# Adaptable Housing Report

3-5 Help Street

**Project:** Project Name & Address  
**Document Type:** Adaptable Housing Report  
**Our Reference:** P222\_481-3 (AS4299) DV

**Drawing No.**  
SSDA-4001

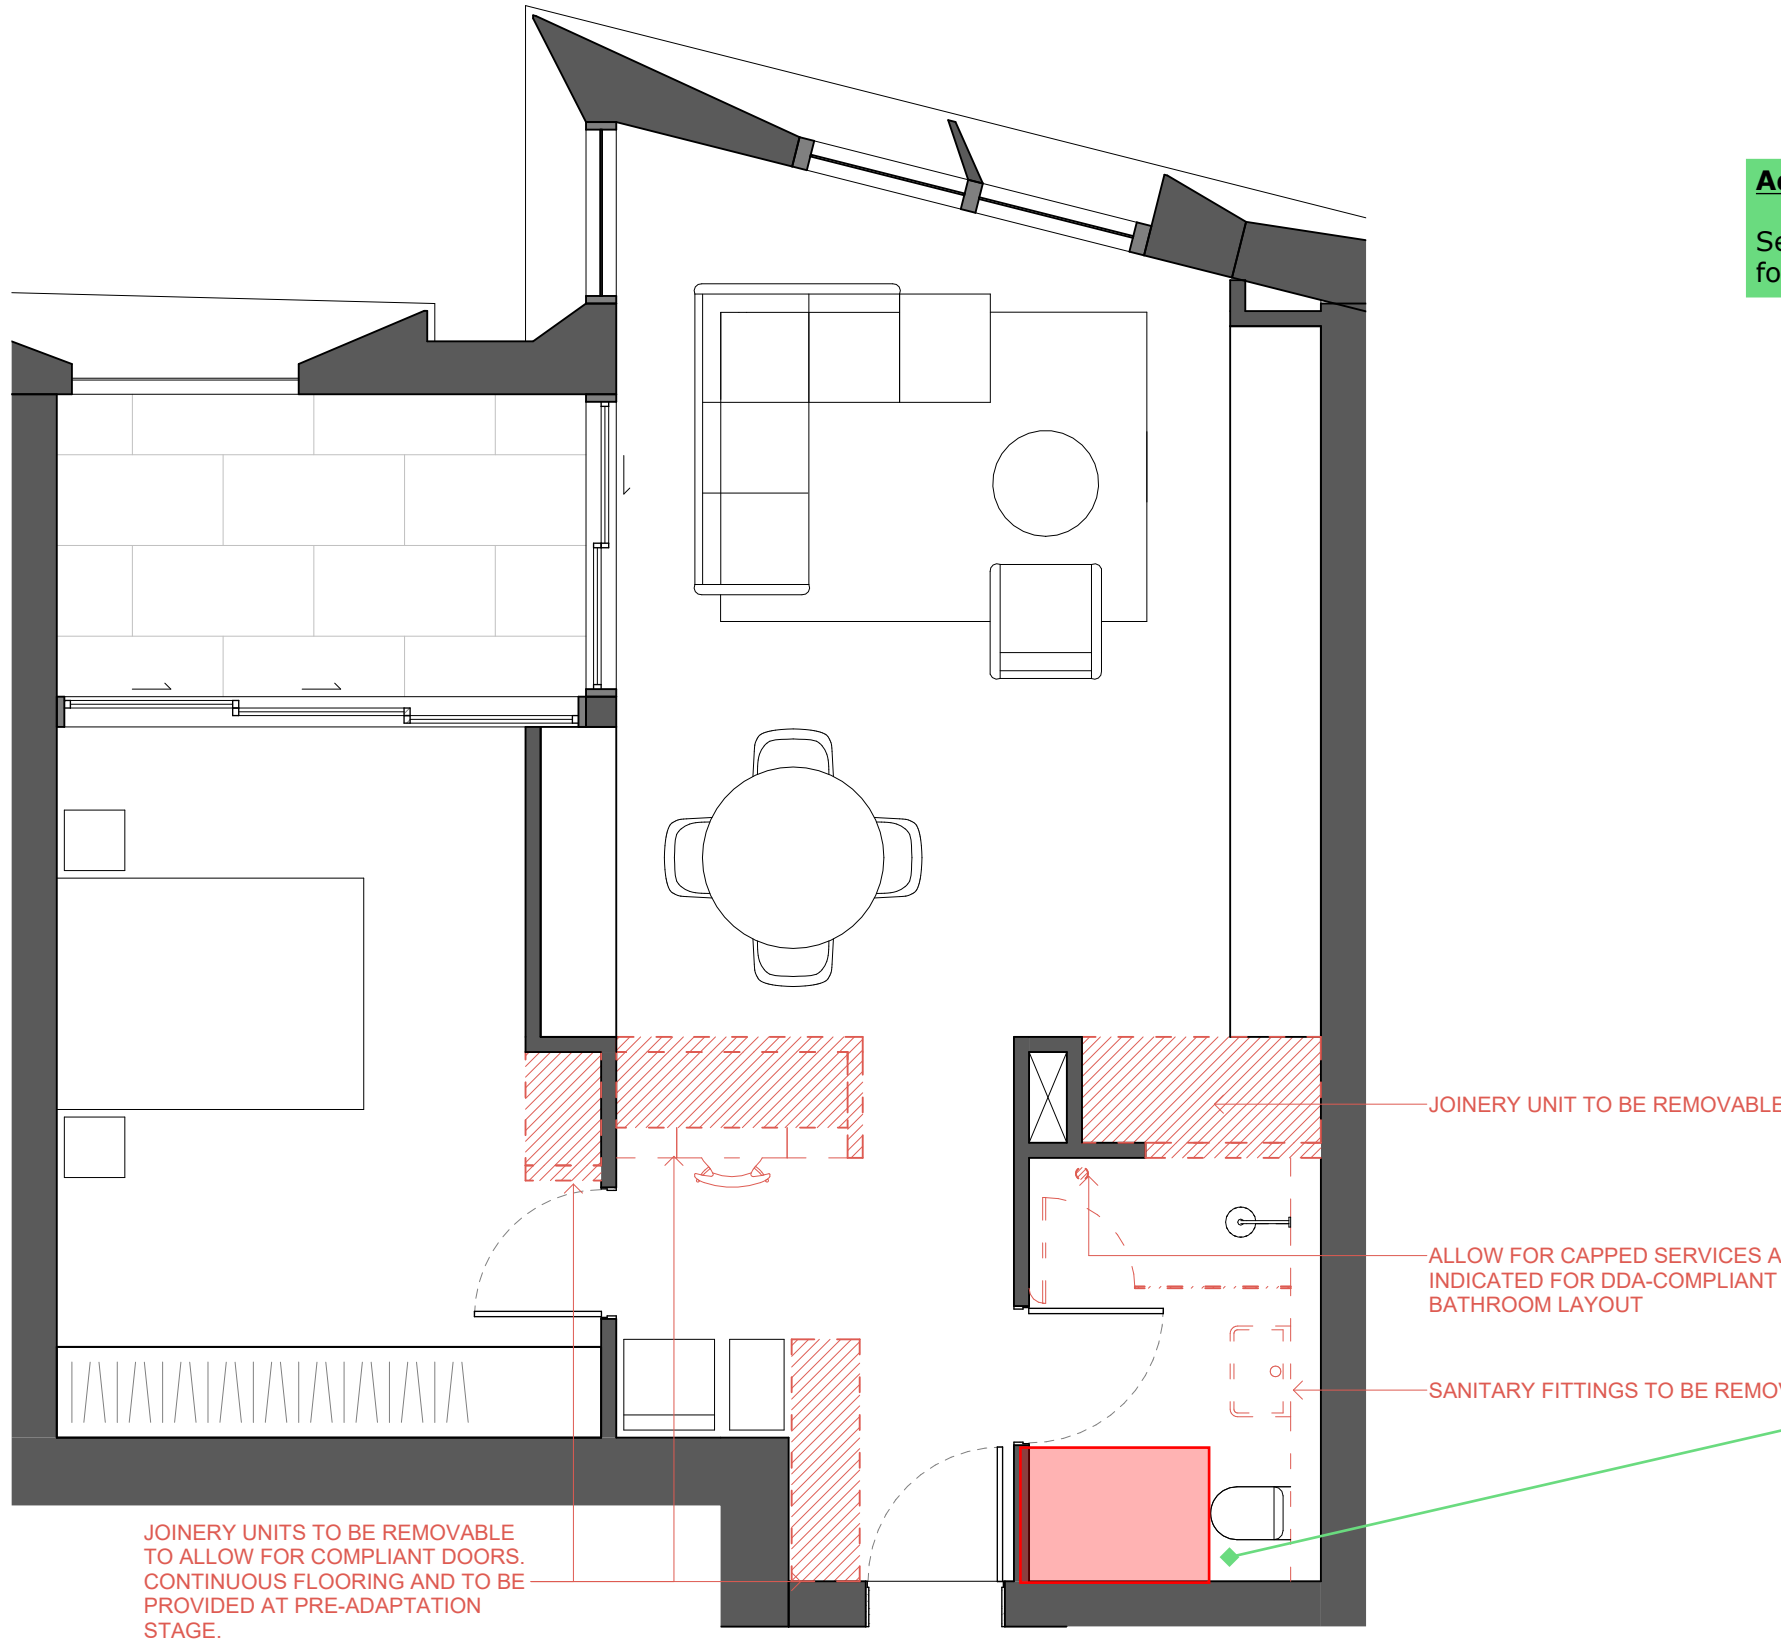
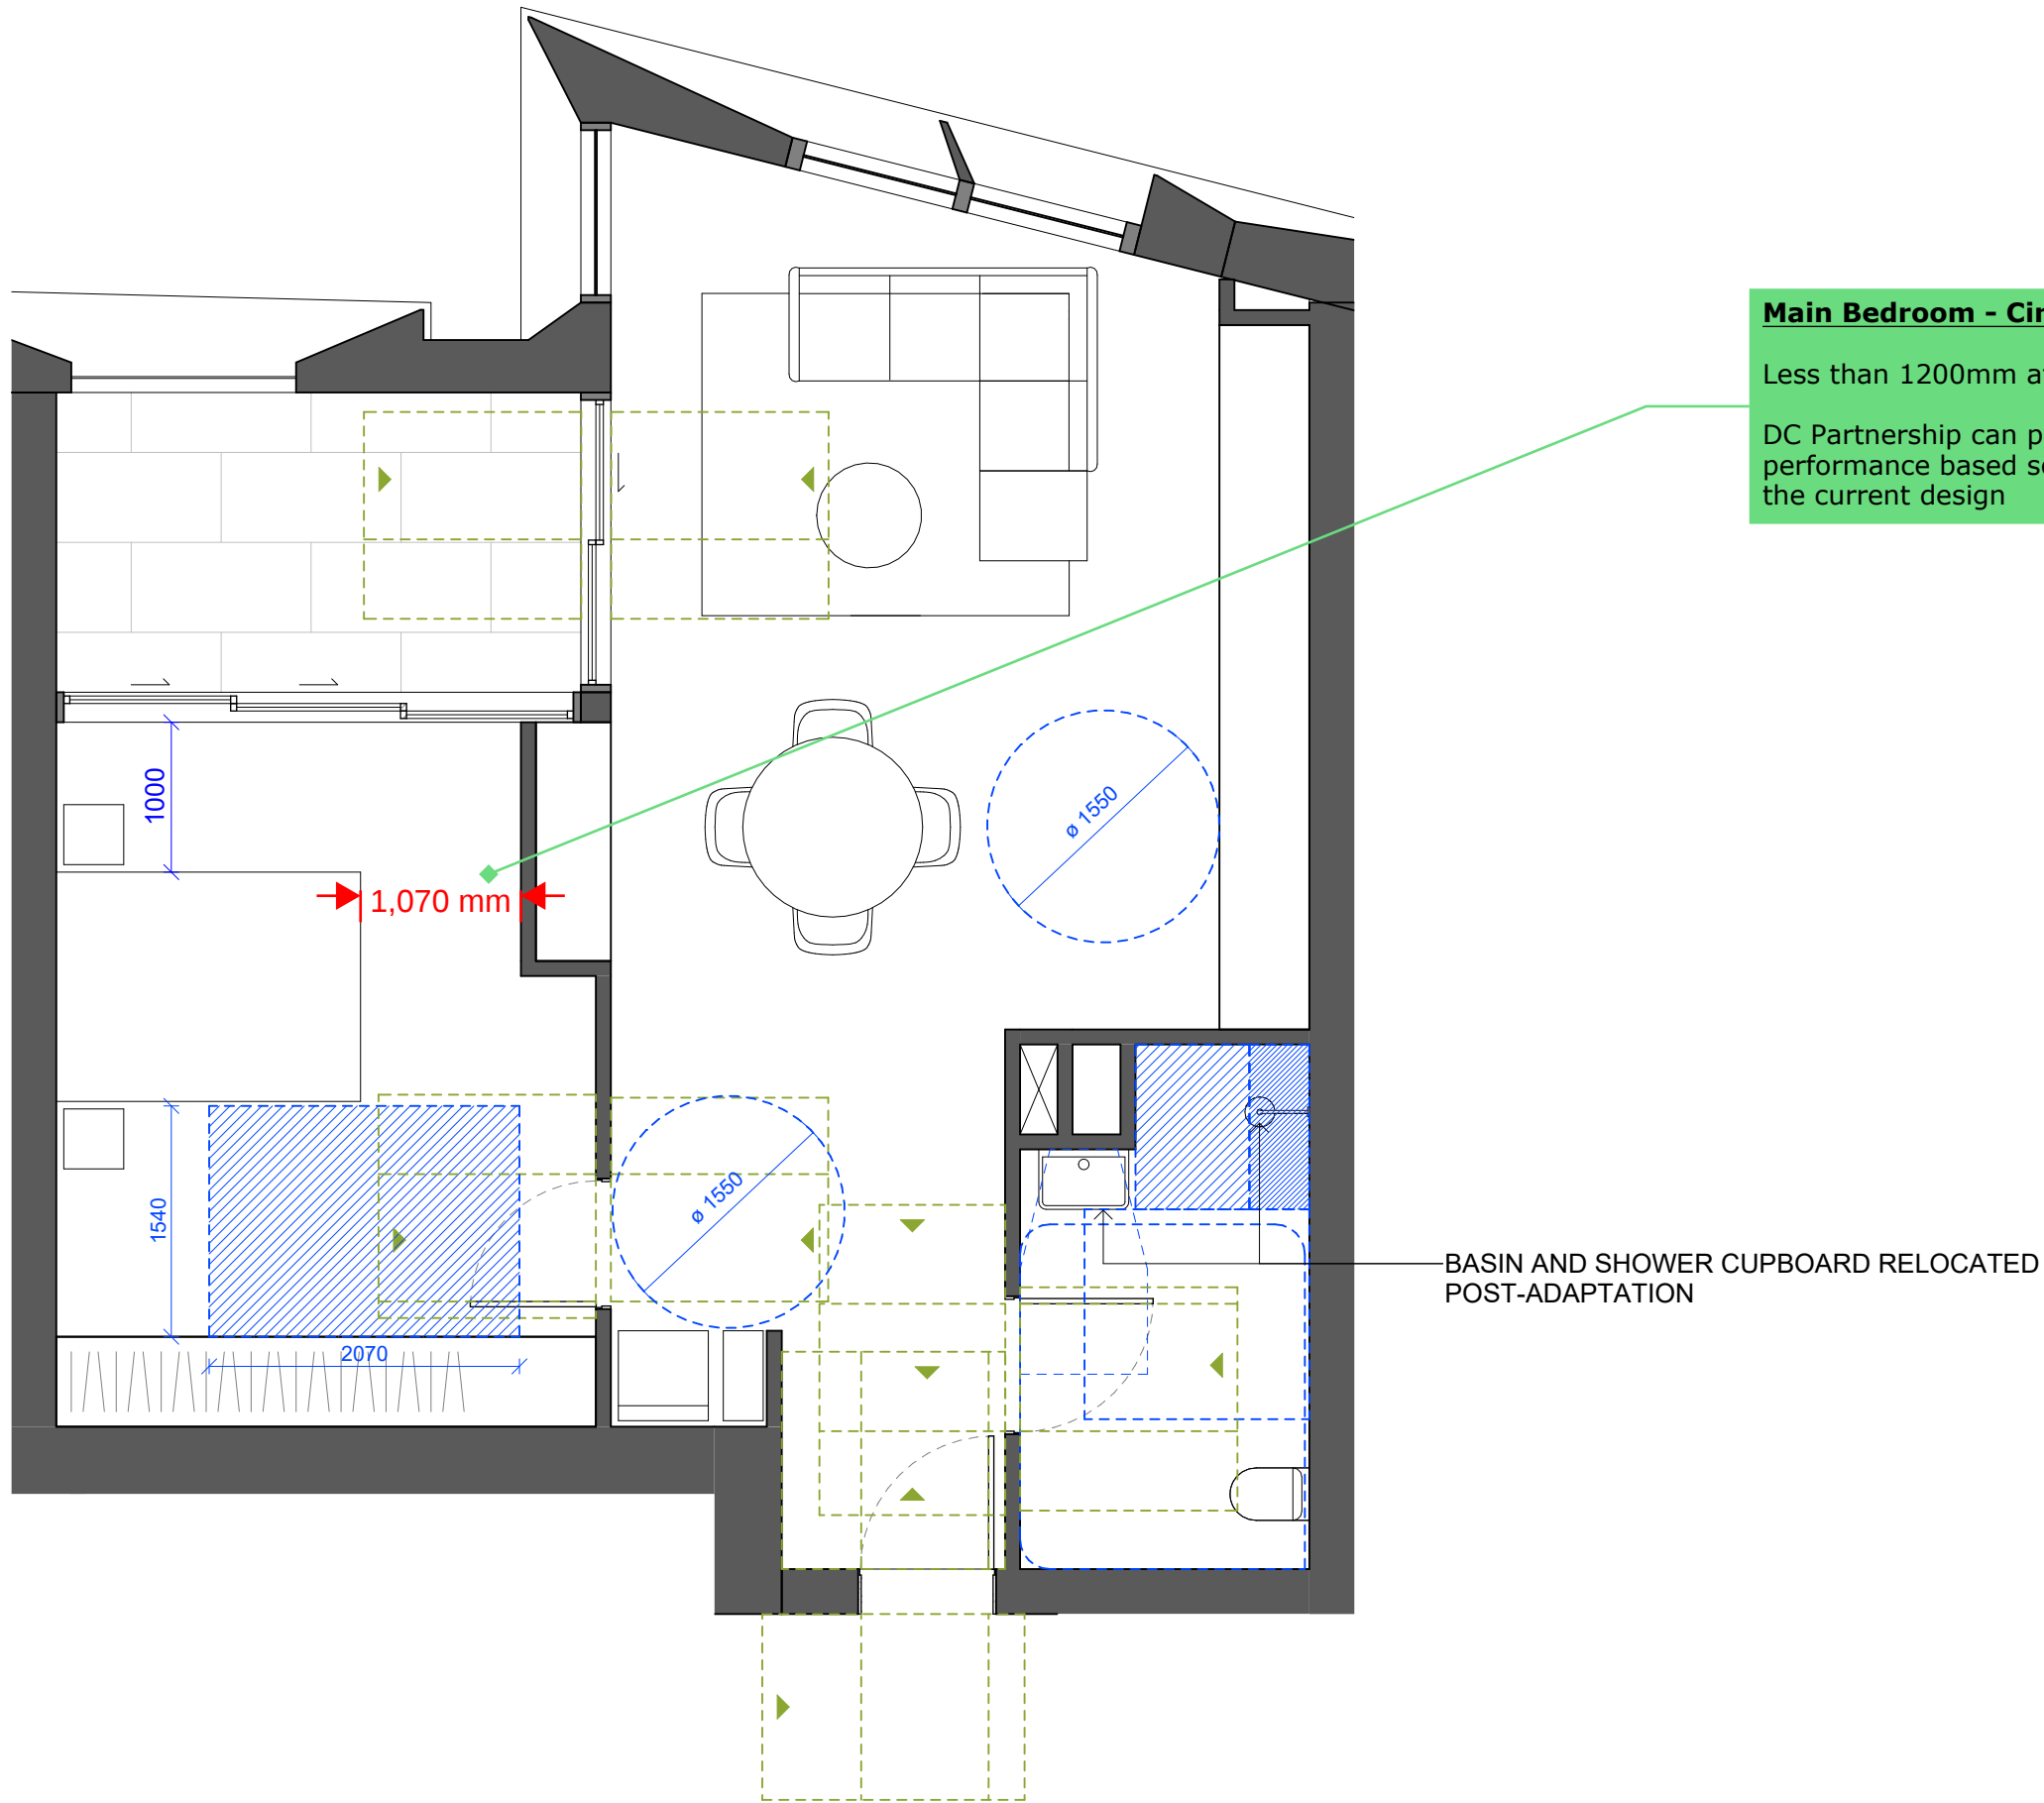
**Adaptable units**  
Sectional drawings to be provided for further assessment.

**Vistable WC**  
- Toilet located at pre-adaptation stage is not provided with 1250mm in front and 900mm clear width.  
- Toilet projection to be minimum 600mm

**Main Bedroom - Circulation Space**  
Less than 1200mm at the end of the bed.  
DC Partnership can provide a performance based solution to a support the current design

**Drawing No.**  
SSDA-4004

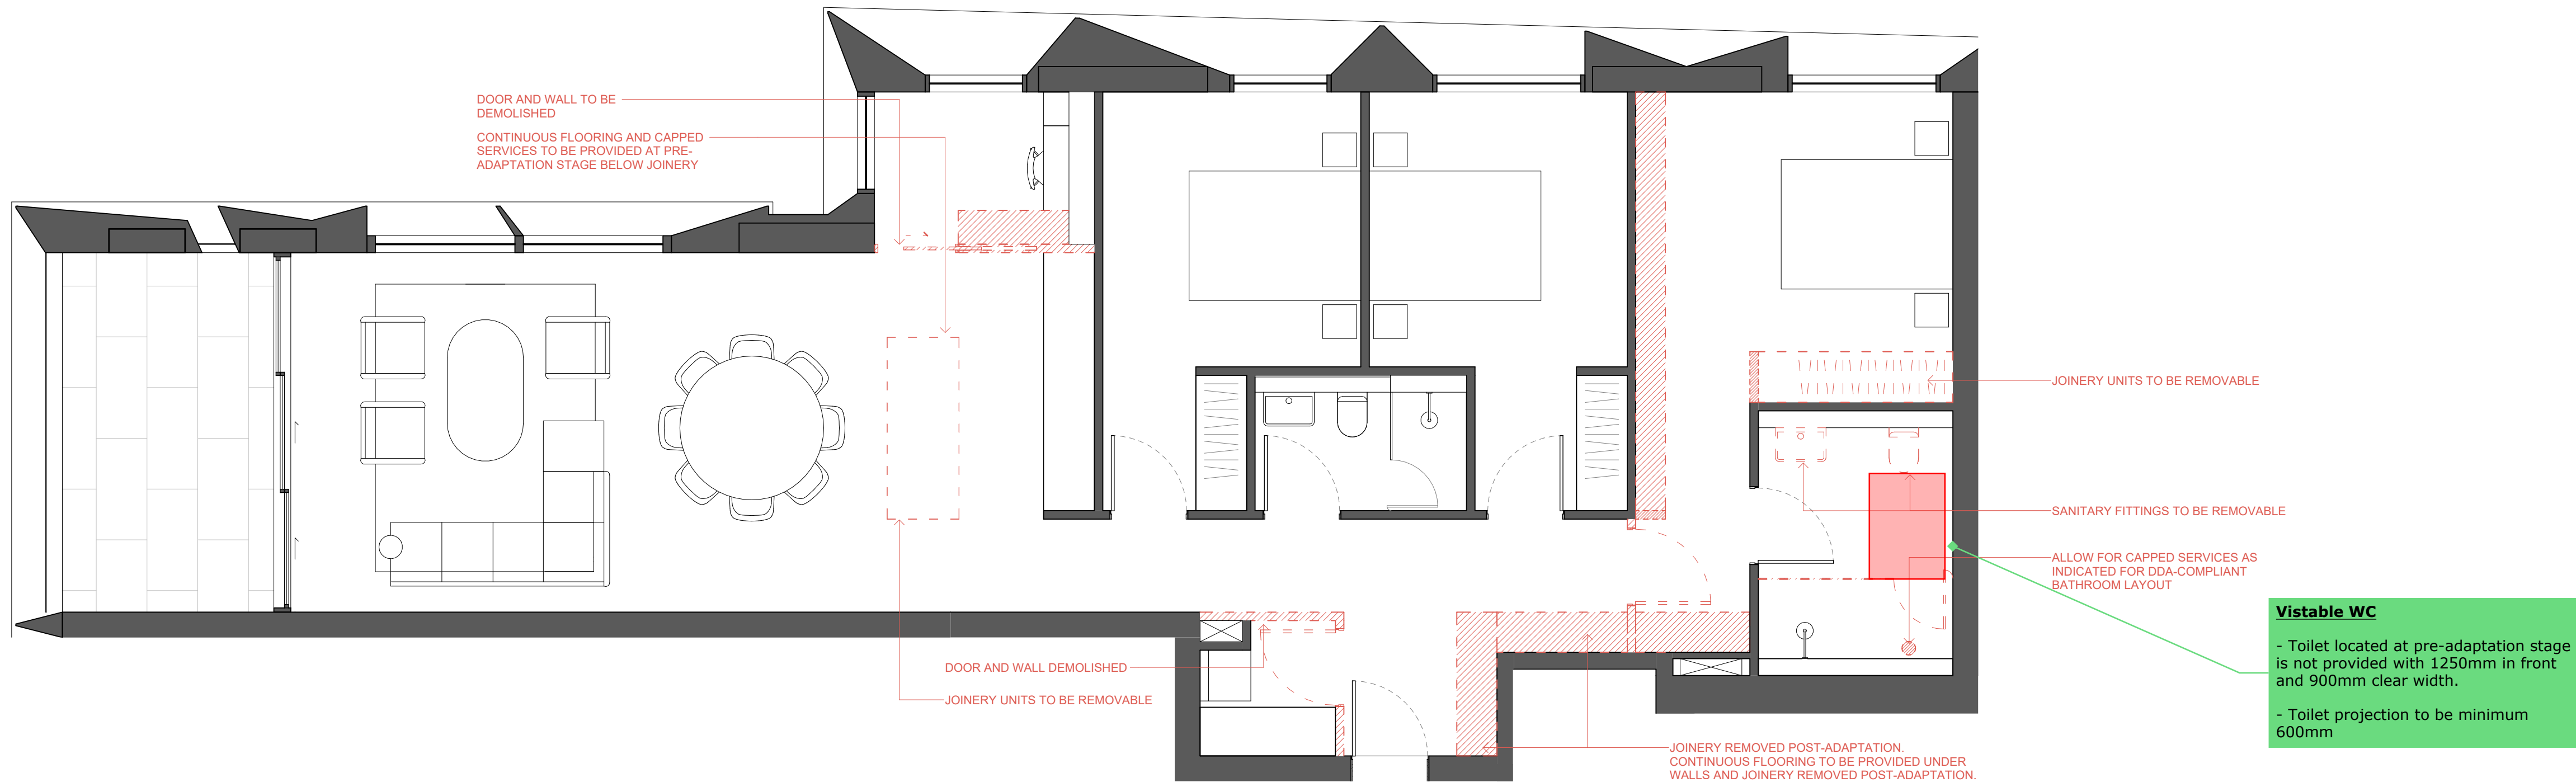
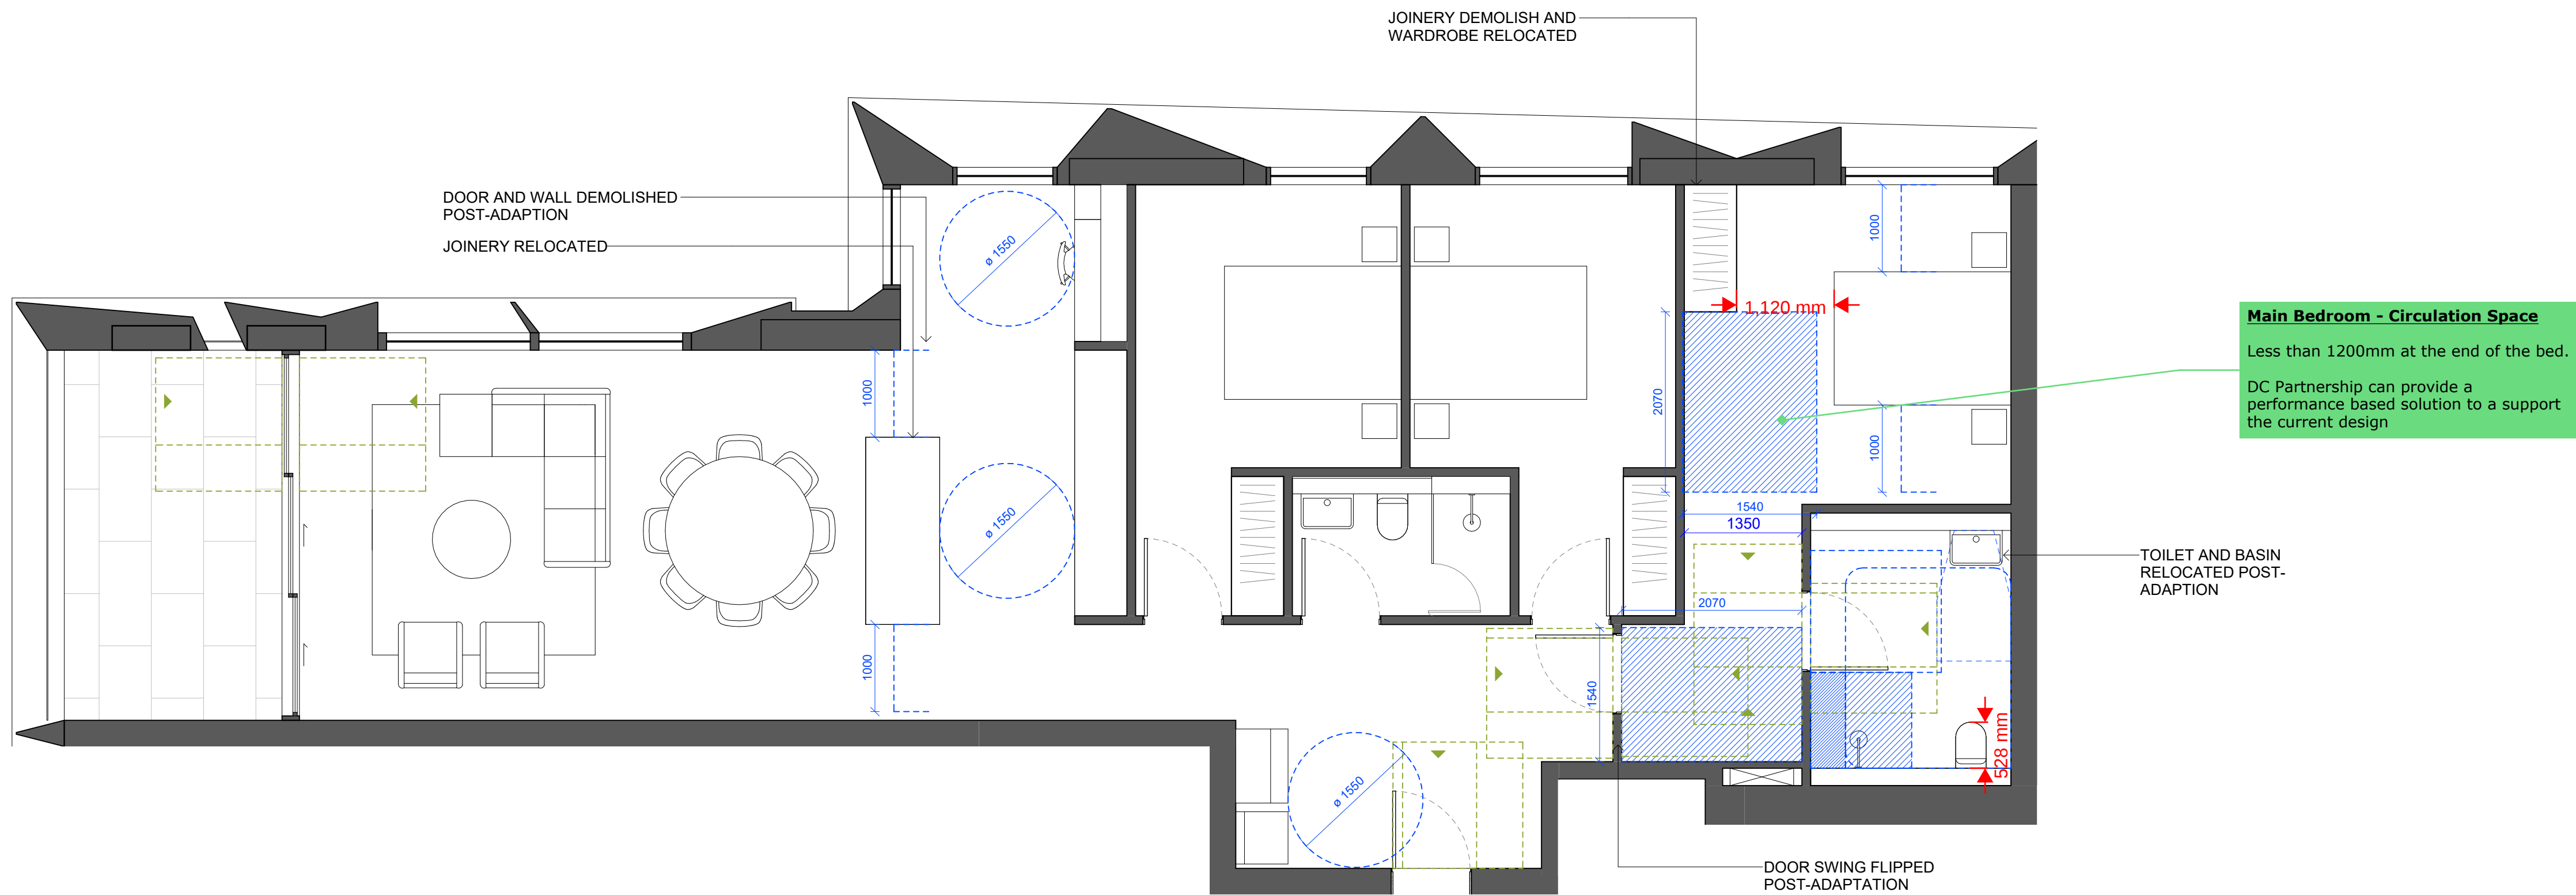
### Adaptable units

Sectional drawings to be provided for further assessment.
